# DEVELOPMENT REVIEW BOARD REPORT

CASE NUMBER/ PROJECT NAME	<b>55-DR-1986#2 CSB Building</b>		
LOCATION	2901 N 78th Street		
REQUEST	Request approval to add two new lobby areas and an exterior paint change to an existing structure.		
OWNER	CSB 480-467-2399	ENGINEER	N/A
ARCHITECT/ DESIGNER	David D. Ortega, AIA 480-991-4224	APPLICANT/ COORDINATOR	David D. Ortega, AIA 480-991-4224
BACKGROUND	<p><b>Zoning.</b></p> <p>The site is zoned Commercial Office District, Conditional (C-O, C) which allows for an office use.</p> <p><b>Context.</b></p> <p>The site is located in the southern portion of Scottsdale Road along the east side of the Indian Bend Wash. The parcel sits at the northeast corner of Thomas Road and 78<sup>th</sup> Street, specifically 2901 N. 78<sup>th</sup> Street. Currently, an existing office building including mature landscaping is located on the site. The Indian Bend Wash and a variety of residential uses surround the building.</p> <p>Adjacent Uses:</p> <ul style="list-style-type: none"><li>• North: Indian Bend Wash zoned Open Space, Planned Community Development (O-S, PCD).</li><li>• South: Indian Bend Wash zoned Open Space (O-S) and existing townhomes zoned Medium Dens

PRIMING NO. **A-1**

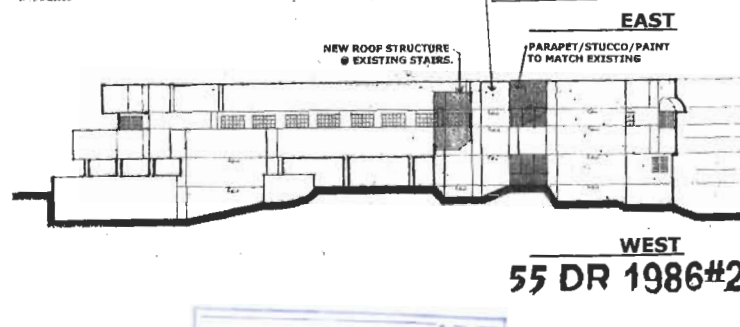
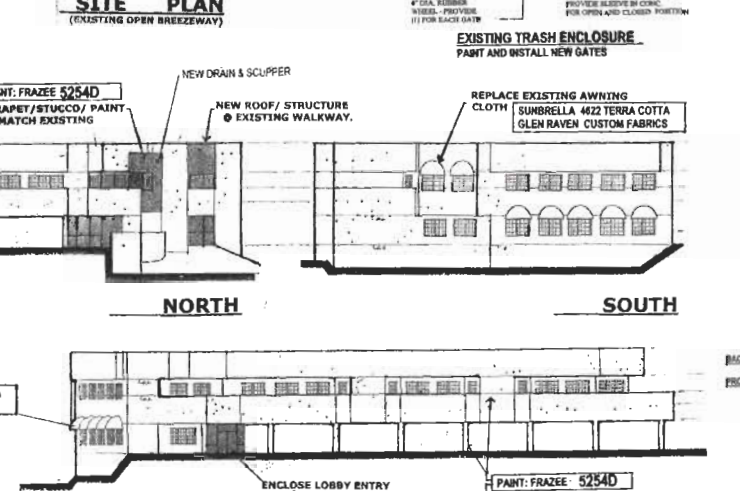
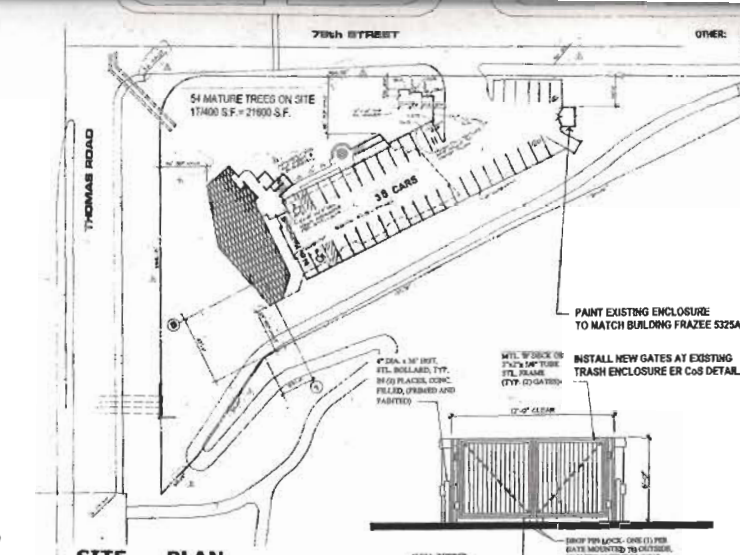
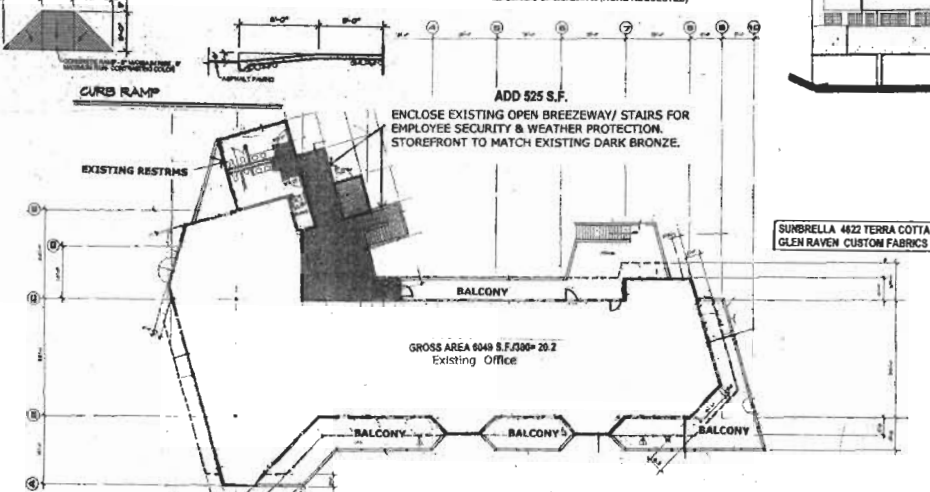
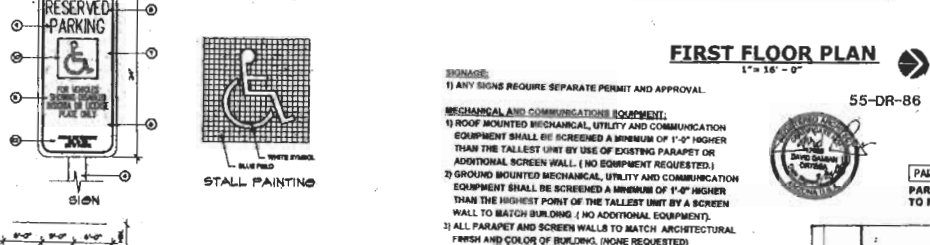
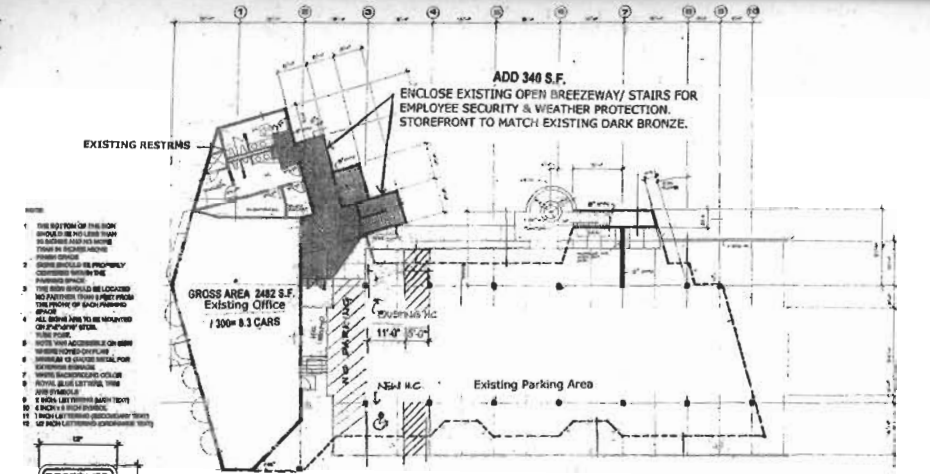
1. Except as required by the City Code of Ordinances, Zoning Regulations, Subdivision Regulations, and the other stipulations herein, the site design and construction shall substantially conform to the following documents:
  - a. Architectural elements, including dimensions, materials, form, color, and texture, shall be constructed to be consistent with the building elevations submitted by David Ortega Architect & Associates with a staff receipt date of 6/8/2005.
  - b. The location and configuration of all site improvements shall be constructed to be consistent with the site plan submitted by David Ortega Architect & Associates with a staff receipt date of 6/8/2005.

15. One (1) additional handicap accessible parking space to be provided on site. Show location of all ADA parking spaces on final site plan.
16. Provide up-to-date parking analysis on final site plan, including handicap parking calculations.
